BINZ-ENGLEMAN
MASTER DEVELOPMENT PLAN
PLAN #: _____

MASTER DEVELOPMENT PLAN

Re: Binz-Engleman Development Subdivision MDP # 812

The City Staff Development Review Committee has reviewed Binz-Engleman Development Subdivision Master Development Plan M.D.P. # 812 . Please find enclosed a signed copy for your files. Your plan was accepted, however please note the following:

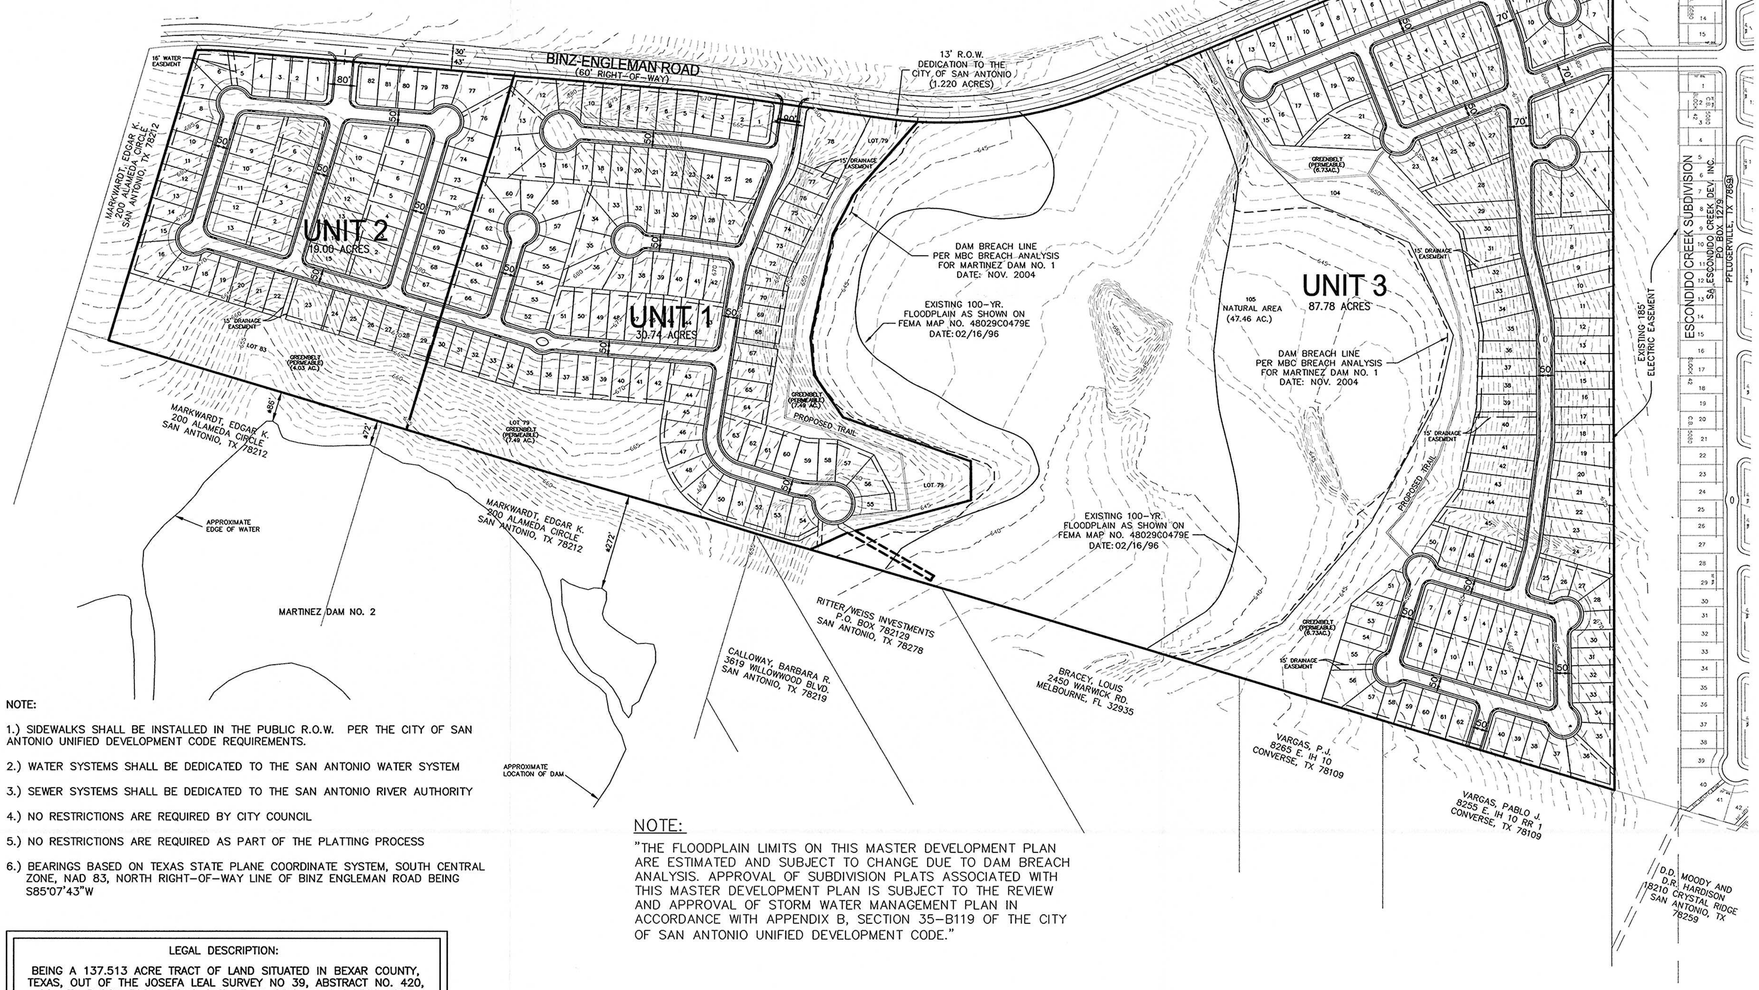
- In consideration of public safety and convenience, excessive grades by reason of topography should be avoided in street layouts and arrangements.

- The acceptance of this Master Development Plan # 812 is confined to the boundary limits of the site. Any projection(s) of future roadways outside the boundaries does not infer any set alignment of future roadways. All major arterials and streets shall follow all regulations.

- Streets and Drainage approves this project with the following conditions:
  1. The following potential issues should be addressed during the respective platting process:

a. For cul-de-sacs greater than 500 feet in total length, the pavement width for the entire length of the CDS shall be a minimum of 30 feet and the turnaround roadway shall have a minimum exterior radius of 50 feet.
     b. Evaluate clear vision easement requirements at several intersections in all three(3) units.
     c. Evaluate need for a drainage interceptor with easement along eastern boundary of Unit 3.
     d. Evaluate need for drainage outfall easement on southern boundary of Unit 2.

1) Intersection sight distance should be used for all intersections
